## TECHNICAL SERVICE BULLETIN

### 3.5L EcoBoost High Output - Lack Of Power And/Or Misfire With Or Without DTCs P0300 Through P0306 - Built On Or Before 1-Jun-2019

**19-2286**  
20 September  
2019

<b>Ford</b> 2019 F-150
---------------------------

Figure 1

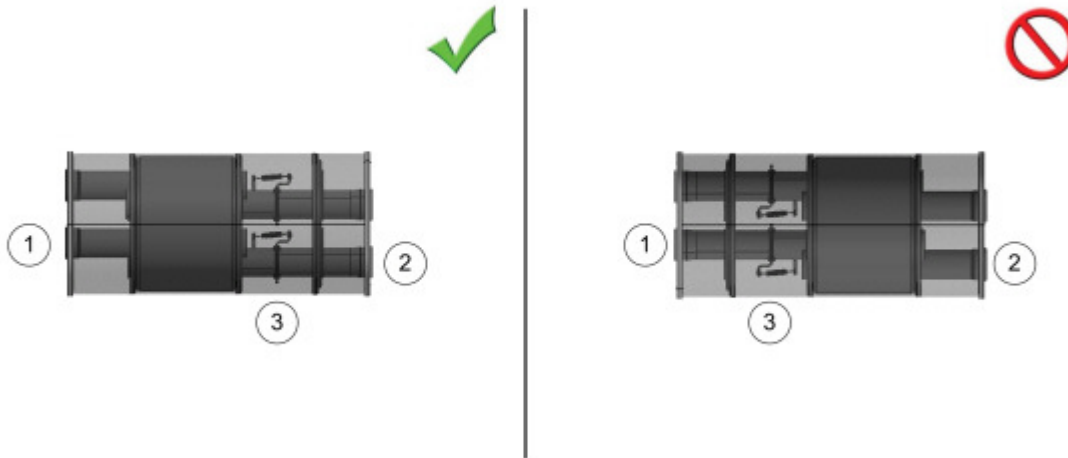
**Issue:** Some 2019 F-150 vehicles with the Limited series package built on or before 1-Jun-2019 equipped with a 3.5L EcoBoost high output engine may exhibit a lack of power and/or misfire condition with or without diagnostic trouble code (DTC) P0300 through P0306. This may be due to the internal components of the muffler assembled improperly. To correct the condition, follow the Service Procedure steps to replace the muffler.

1. Disconnect the inlet side of the muffler. Refer to Workshop Manual (WSM), Section 309-00.
2. Insert a tape measure into the inlet side of the muffler assembly until it bottoms out. (Figures 1-2) Is the measurement at the end of the tube 584 mm (23 inches) or less?
  - (1). Yes - proceed to Step 3.
  - (2). No - this article does not apply. Refer to WSM Section 309-00 for normal diagnostics.

3. Replace the muffler assembly. Refer to WSM Section 309-00.
